**Scientific Analysis  
Administrative Change Notice**

<b>1. Document Number:</b>	ANL-NBS-HS-000005	<b>2. Revision:</b>	03	<b>3. ACN:</b>	01
<b>4. Title:</b>	In Situ Field Testing of Processes				
<b>5. No. of Pages Attached:</b>	8

Figure 1-2. Schematic Illustration of Alcove and Niche Locations in the Exploratory Studies Facility at Yucca Mountain

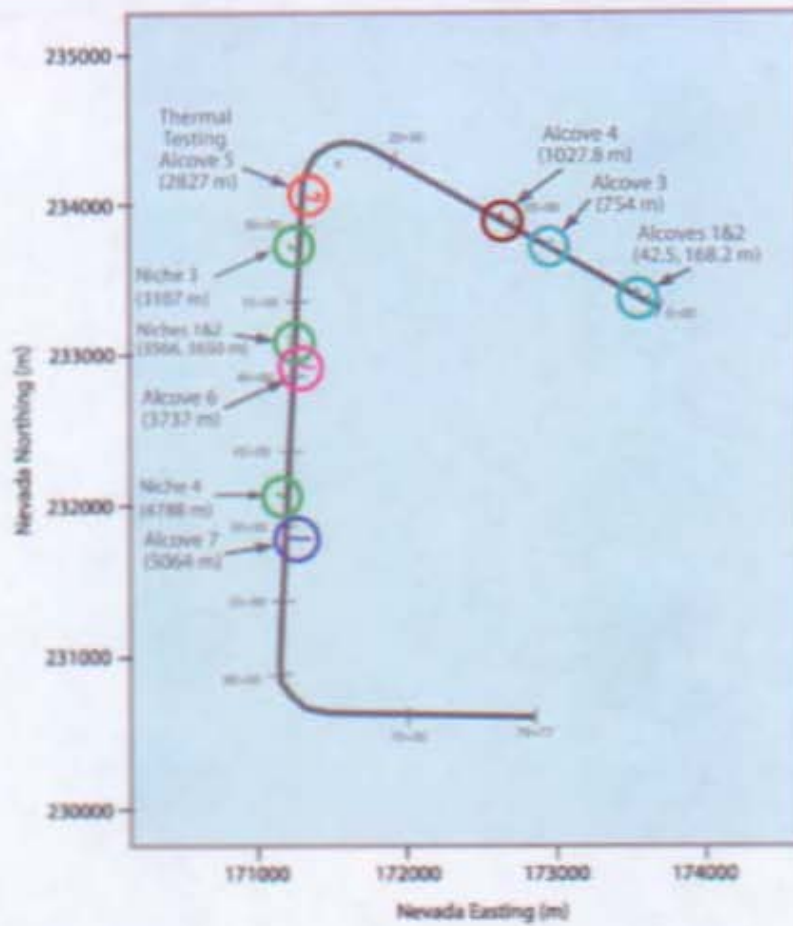
7. Affected Pages	8. Description of Change:
1-7	<p>Editorial Change</p> <p>Figure 1-1, change the caption of the figure:</p> <p>“Schematic Illustration of Spatial Distribution of Hydrogeologic Units Intersected by the Repository Horizon (Ttpul, Ttpmn, Ttpll, and Ttpln)”</p> <p>To</p> <p>“Schematic Illustration of Spatial Distribution of Lithostratigraphic Units Intersected by the Repository Horizon (Ttpul, Ttpmn, Ttpll, and Ttpln)”</p> <p>This error is identified in CR-5920</p>
1-8	<p>Correct figure</p> <p>Figure 1-2 “Schematic Illustration of Alcove and Niche Locations in the Exploratory Studies Facility at Yucca Mountain”, <b>delete the background geology.</b></p> <p>Note: This figure should only show the locations of ESF alcoves, niches, and station numbers. The geology is provided in Figure 1-1.</p> <p>This error was identified in CR-5920</p>
